NUMBER: 08-048-14 REV. B

DATE: October 30, 2014

Flash: Vehicle Enhancements

2013 - 2014 (FF) 500e

Fig. 1 Interior fuse panel located by the left kick panel.

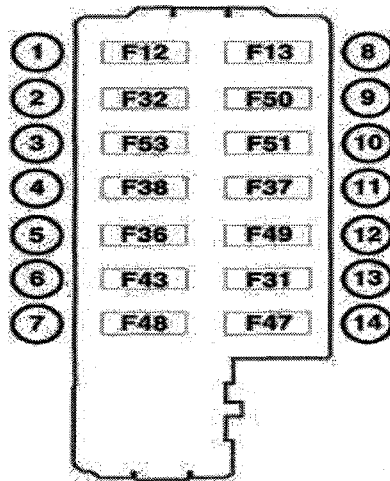
15. Is U11F6-00 set as an active fault?
 - a. Yes >>> Proceed to Step #16.
 - b. No >>> Proceed to Step #18.
16. Turn off the ignition and pull fuse F36 for 10 seconds. It is located in the interior fuse panel, which is part of the BCM, see (Fig. 1).

Remove fuse F36 .
